MINUTES OF THE REGULAR MEETING OF THE PLAN COMMISSION, VILLAGE OF TINLEY PARK, COOK AND WILL COUNTIES, ILLINOIS

July 21, 2022

**ITEM #3 PUBLIC HEARING – OTTEN’S SEAFOOD, 7313 DUVAN DRIVE –
VARIATIONS AND SITE PLAN/ARCHITECTURAL APPROVAL**

PLAN COMMISSION STAFF REPORT

Architectural Elevation and Photo of Front Facade (per Petitioner)

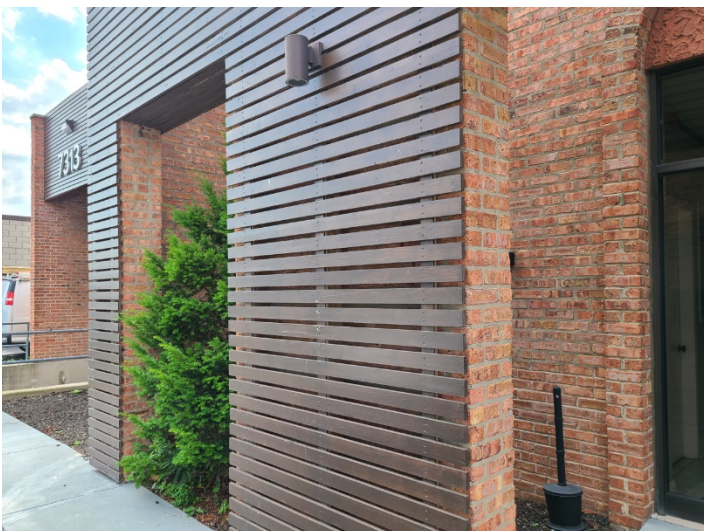
The Petitioner installed cladding consisting of wooden slats on a portion of the front façade and signage. The Petitioner states he was unaware that Variations and Site Plan/Architectural approvals were required prior to changing the façade nor did he contact the Village to see if a permit was required for such work. The Variations required are:

- Masonry Variation from Section V.C.7.F.2. of the Zoning Ordinance to allow the front façade to have less than 75% of face brick
- Alternative Building Material Variation from Section V.C.7.G. of the Zoning Ordinance to allow the front façade to contain more than 15% of an alternate building material

He notes the façade change is an aesthetic improvement to the property and the varied appearance of the Duvan Drive neighborhood, and that the wood cladding is a light, decorative treatment. He states he chose this modern and clean appearance to help keep in demands of customers in the industry. The cladding treatment is only on portions of the front façade. The cladding is dark brown 1" x 2 ½" slats secured to the building via weatherproof concrete anchors every two feet. Some of the cladding is directly attached to the brick wall. Other areas with varied relief of the brick arches have vertical wood members (2"x6"s or less) between the cladding and brick for a flat and streamlined appearance of the cladding.

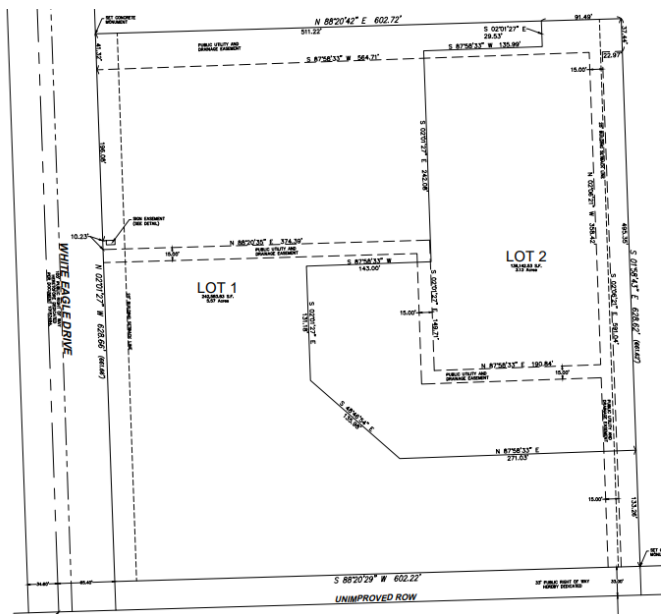
The design of the lots is unique because the Residence Inn/Lot 2 will not have direct access to the adjacent White Eagle Drive right-of-way and will have permanent access through a cross-access (ingress/egress) easement with the Courtyard/Lot 1. The Zoning Code specifically allows for properties with unique lot, land, or use circumstances to have a lot that does not abut the public right-of-way, subject to appropriate cross-access and utility easements. In this case, the lot and site design were chosen due to the existing wetland location, detention location/topography and the large building footprint required for a hotel.

from the west property line, not 4 ft. The Petitioner is revising the Final Plat of Subdivision to indicate the correct location of the sign easement.

1. The Final Plat's sign easement location shall be revised to be five feet from west property line, and coordinated to be in the area of the boulevard entry's median.
2. The Final Plat approval is subject to Final Engineering Plan approval by the Village Engineer, MWRD, and the U.S. Army Corp of Engineers.”

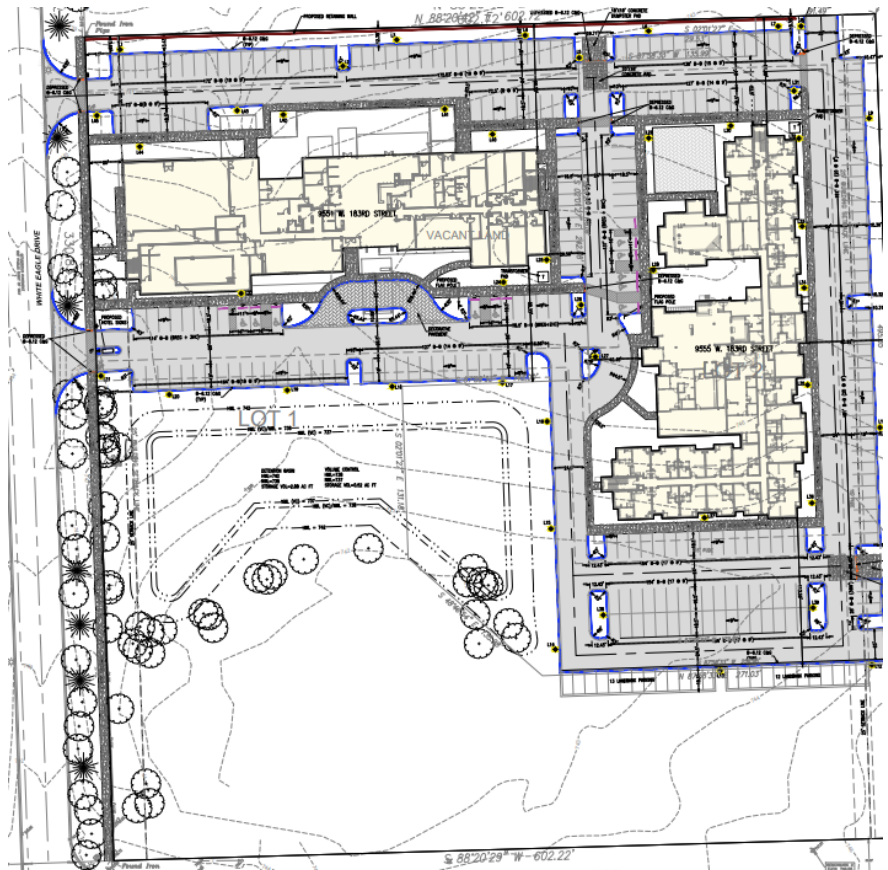
The Site Plan does not indicate specific building setbacks for each façade to the lot lines. Previously, the Plan Commission did not express concern for the proposed Variations in height due, lot size, or UDOD requirements. In the 2020 review, as requested, staff confirmed the closest residential structure (Heritage Club Villas) to the hotels will be approximately 808 ft. from the Residence Inn building.

Open Item #2: Revise plans to indicate all proposed structure setbacks.

The Petitioner provided an updated Site Plan showing all property building setbacks, with the exception of the maximum front yard setback for the Residence Inn. The Petitioner is revising the Site Plan to include this.

Table A

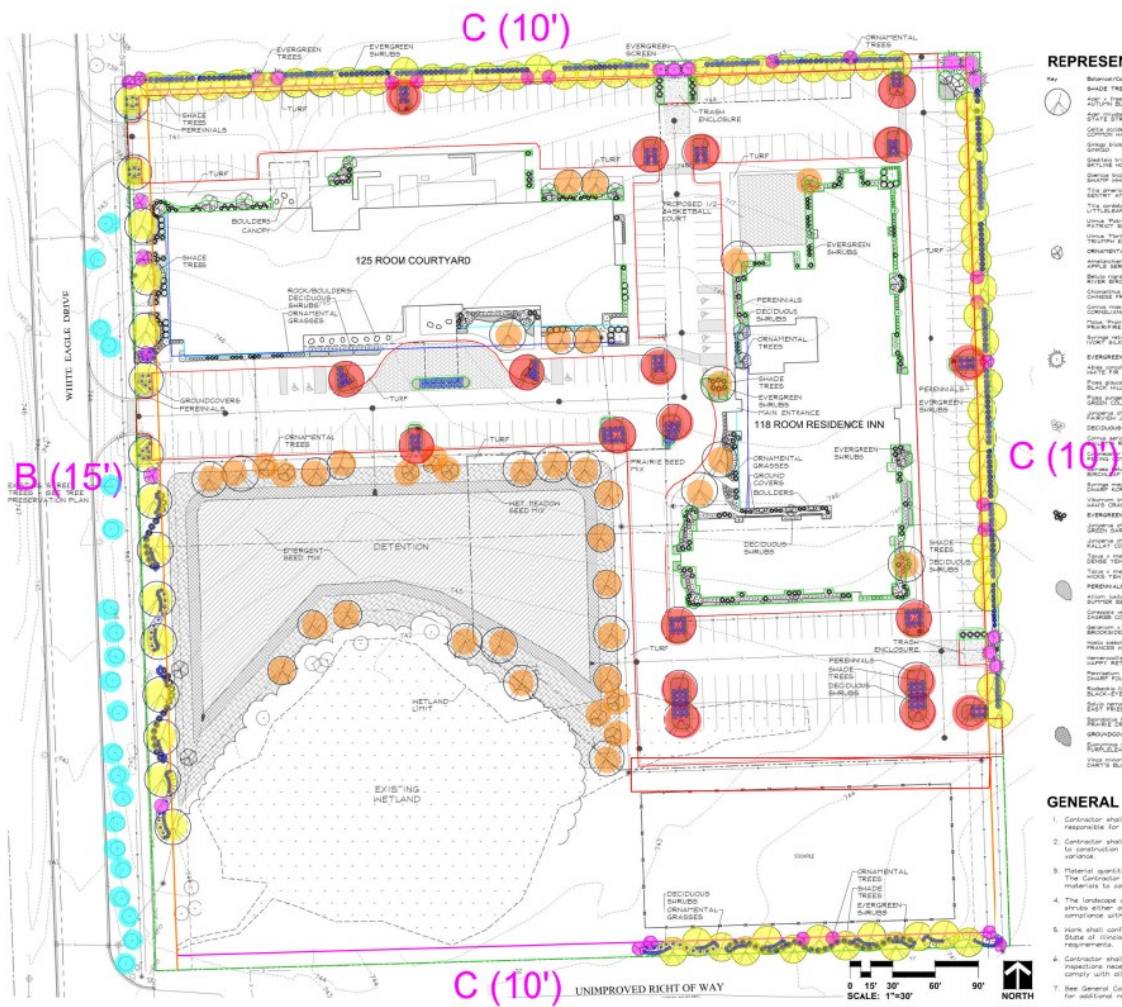
1. To meet the 5,151 sq. ft. interior landscaping deficit (from 15,515 sq. ft. required as 15% of the 103,435 sq. ft. parking lot area), additional landscaping could be added between the 'stockpile' fence /parking lot, or along the south side of the parking lot that is just north of the detention / wetland complex.

2. Add additional islands/bufferyard space at the two driveway entrances to comply with the 15 foot bufferyard requirement. This allows for more attractive entrances and additional space for the ground signs to be located. Meeting this requirement will result in a reduction of six proposed parking stalls.

3. There appears to be room for missing plantings to be accommodated on the east bufferyard. The south bufferyard is deficient, however, there is an existing wetland which will help provide buffering.

4. Add canopy trees to the two internal islands located between the hotel buildings.
5. Add shrubs around the proposed open games area.

The Petitioner is revising Landscape Plans per Village staff suggestions per the Plan Commission Workshop staff report. The Petitioner has confirmed the Landscaping Plans will comply with landscape code requirements.

Updated Courtyard Signage (Top) East, (Bottom): North and South.

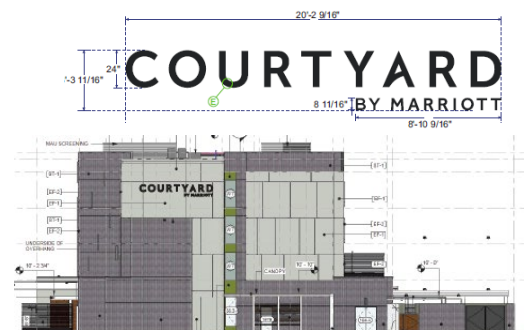
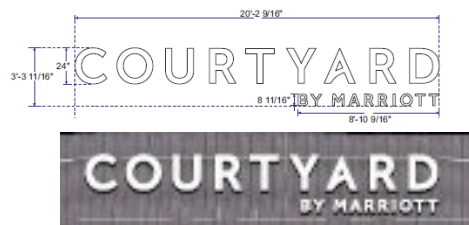
Ground/Freestanding Sign(s) – The Petitioner previously indicated drawings that showed two ground signs flanking the south drive entrance from White Eagle Drive, for each of the hotels with aluminum facing detailed for the Residence Inn ground sign, complying with size and height Zoning Code requirements. The Petitioner has requested a Variation for the Residence Inn's ground sign to be located off-site, on Lot 1 (Courtyard lot). The Plat of Subdivision indicates a sign easement, and is reflected on the Site Plan. The Petitioner now proposes a single shared monument (ground) sign on Lot 1 with two faces for Residence Inn and Courtyard to be located five feet from the property line setback. The Petitioner has confirmed that the size and height requirements will comply with the Zoning Code. Additionally, the sign will have a solid brick base matching the brick on each building.

The Petitioner has stated that the ground signage will consist of a single, shared monument ground sign to be located at the center of the boulevard driveway entry to the development. In order to allow for the sign facing on the Residence Inn, the Petitioner will continue to request the off-site sign variation, five foot sign setback variation, and shall have the sign easement located in the correct location on the Plat of Subdivision.
